APPLICATION FOR A CERTIFICATE OF APPROPRIATENESS – STAFF REPORT

153-17-CA 503 E JONES STREET Applicant: ROBERT RIEDLINGER

<u>Nature of Project</u>: Remove rear addition; construct rear addition; alter addition roof; construct side porch with fireplace; add new brick walk; install fencing

2 SCONCES AT 2 SIDES OF DOORS

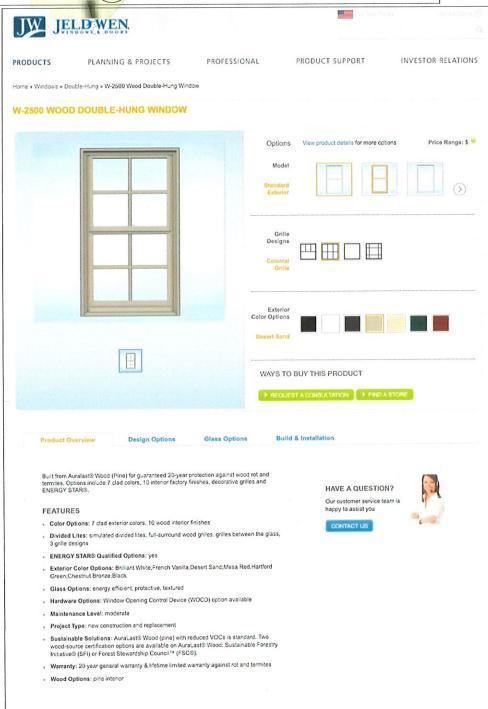
- 12* The north addition for the master bedroom will also have a grouping of three doors on the north wall with a series of transoms above. Groupings of doors on the rear of new additions are commonly approved in the Oakwood historic district.. Door specifications were not provided.
- 13* The proposed north addition will be covered with a metal roof that matches what is on the rebuilt kitchen/maid's house. Specifications were provided.
- 14* Skylights are proposed on the north addition. Specifications were not provided.
- 15* Siding specifications were not provided.
- 16* The proposed north addition will take the place of an existing brick patio.
- 17* A light fixture spec was provided, but there was no indication on the elevation drawings where they would be installed.

- c. Roof specs for the former breezeway;
- d. Skylights;
- e. New doors;
- f. Lighting location;
- g. Brick sample for fireplace;
- h. Fence material description;
- i. Fence gates (if any);
- j. A detailed drawing of the new walkway, including brick pattern;
- k. Brick sample for walkway and screened porch floor;

1 BACK ELEVATION/NORTH-PROPOSED
Scale: 3/32" = 1'-0"
0 5 10 15 20 FT

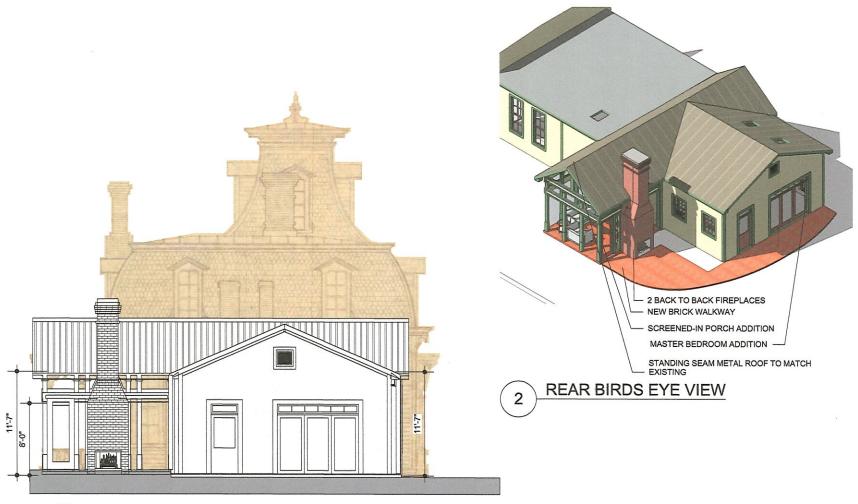
- 5* Page 15 of the application erroneously labels the rear elevation as proposed; it is existing and is the current rear of the rebuilt kitchen/maid's house

COLUMN AT SCREENED PORCH Scale: 1/4" = 1'-0"

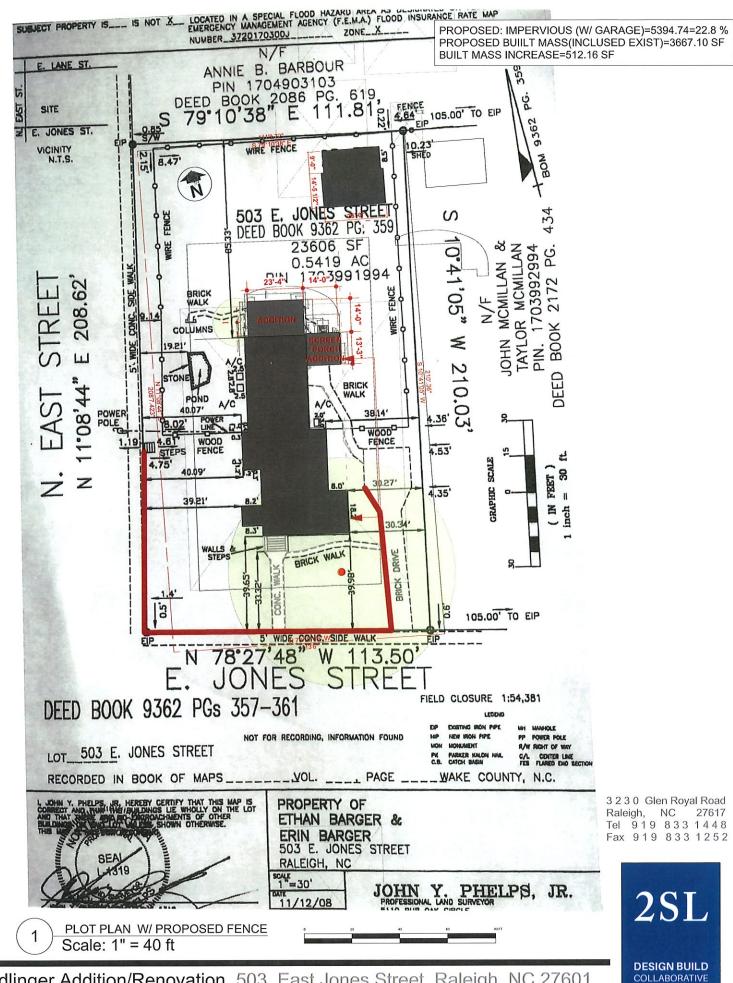
- 5* A detailed drawing of the screened porch was provided. The new porch framing elements and posts will be simplified versions of the historic front porch.

- 7* The screened porch will be covered with a metal roof that matches what is on the rebuilt kitchen/maid's house. Specifications were provided.
- 8* Paint colors which appear to match the existing house were provided, however the details on how the screened porch will be painted were not.
